**TOWN OF NEWBURGH
PLANNING BOARD
TECHNICAL REVIEW COMMENTS**

PROJECT NAME: SHOPPES AT UNION SQUARE PHASE III
PROJECT NO.: 23-16
PROJECT LOCATION: 1217 & 1219 ROUTE 300
SECTION 96, BLOCK 1, LOT 6.2 & 11.11
REVIEW DATE: 9 OCTOBER 2024
MEETING DATE: 17 OCTOBER 2024
PROJECT REPRESENTATIVE: KARC PLANNING CONSULTANTS

TOWN OF NEWBURGH FIRE PROTECTION FLOW TO BLDG. CONNECTION DETAIL

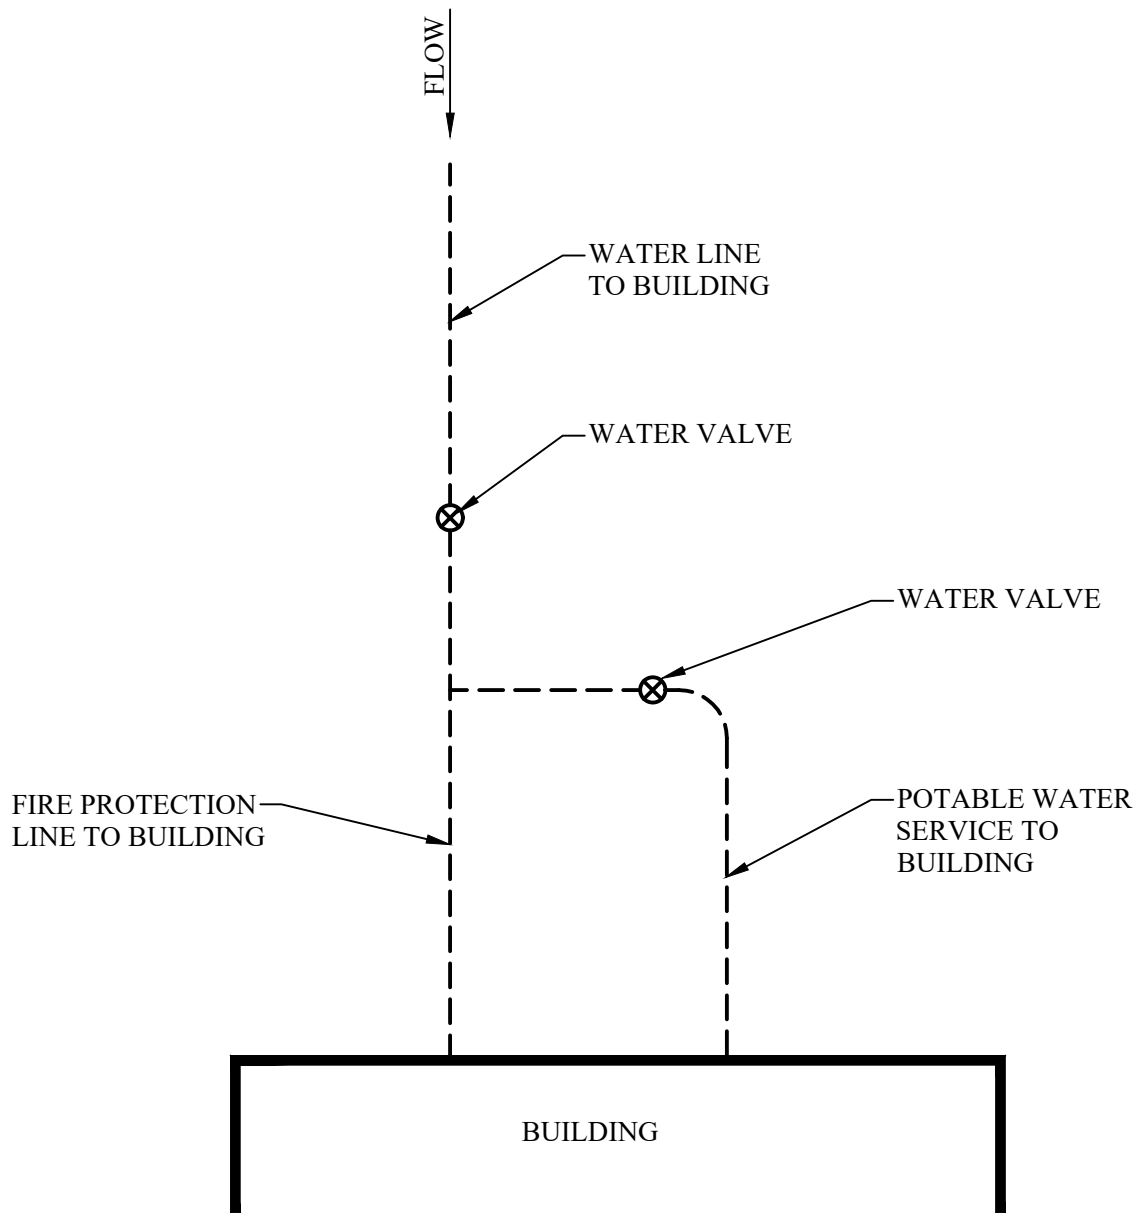
16. The fire flow water/potable water connection to the climate controlled building should be detailed per the town standard detail where potable water is terminated in fire flow water is terminated. Detail attached.

NOTE:
VALVING MUST BE ARRANGED SO THAT
POTABLE WATER IS TERMINATED IF
FIRE PROTECTION LINE IS TURNED OFF.

**SOIL EROSION AND
SEDIMENT CONTROL
PLAN**

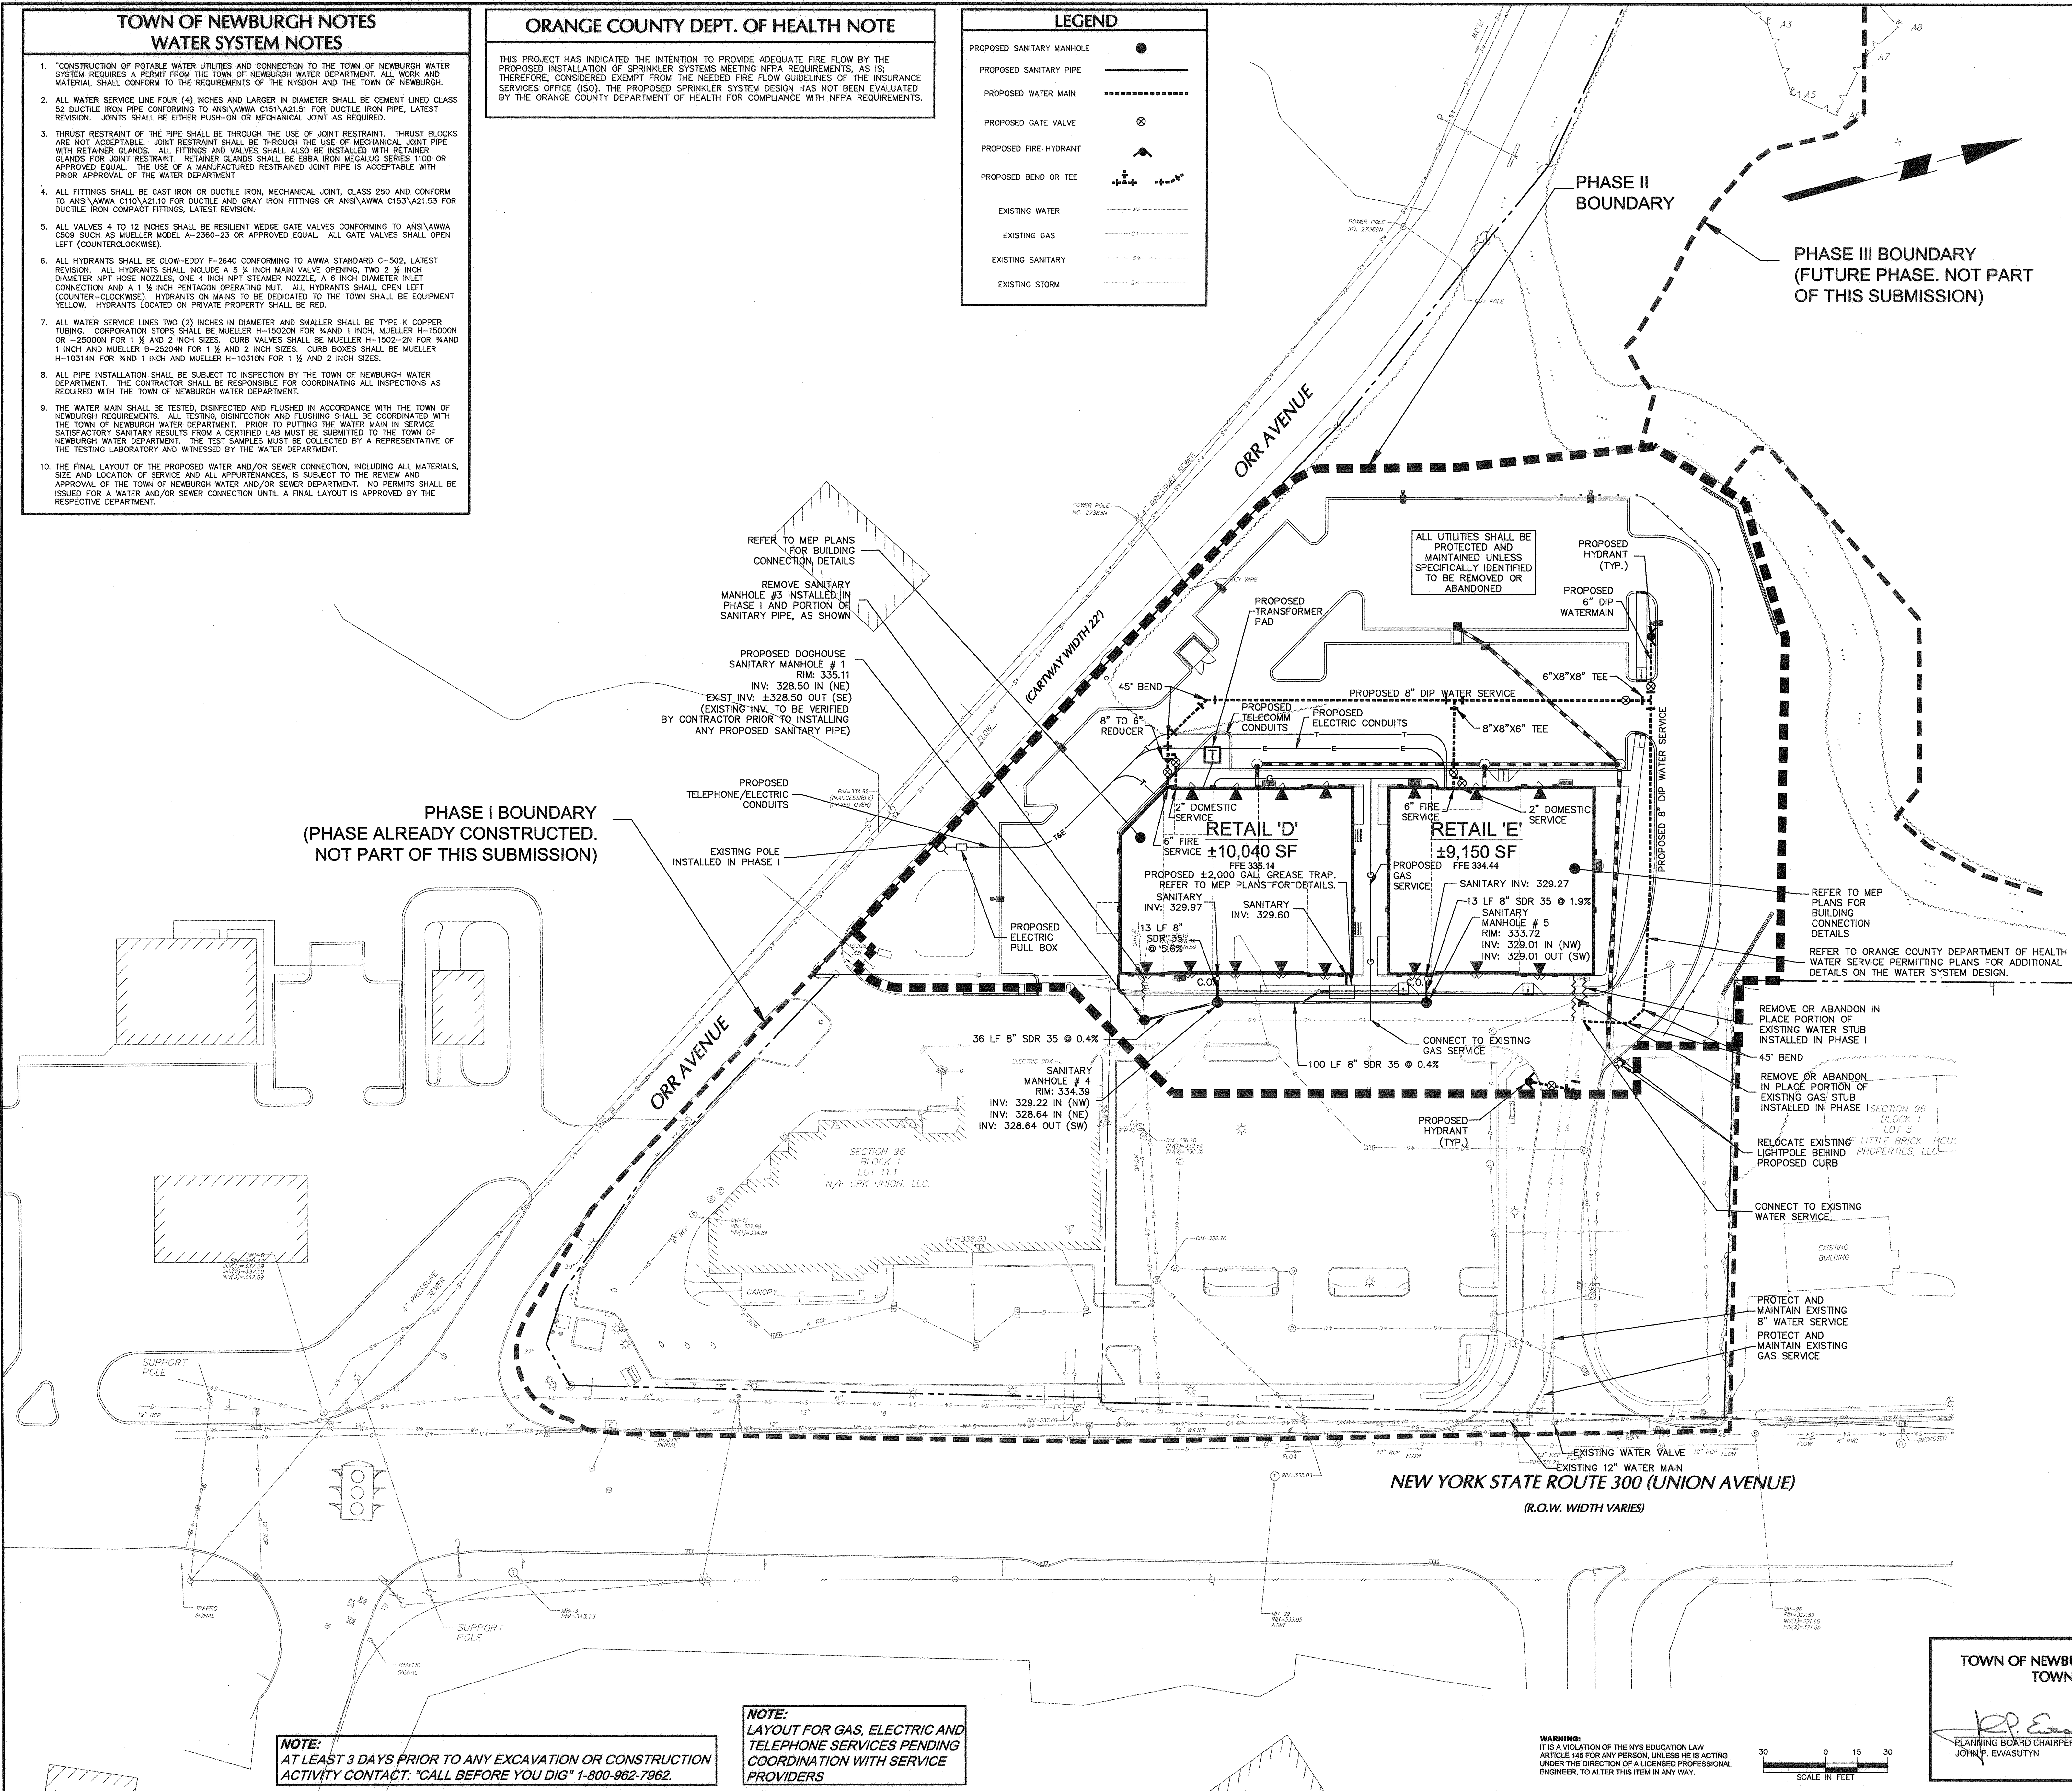
11. Sediment traps are depicted on the Erosion and Sediment Control Plan. Sizing of the temporary sediment traps should be identified based on tributary area.

12. Concrete wash out areas should be depicted on the Erosion and Sediment Control Plan.
13. Confirm that all lighting is dark sky compliant. It is noted that fixture mounting height for pole mounted lights are 20 feet high.
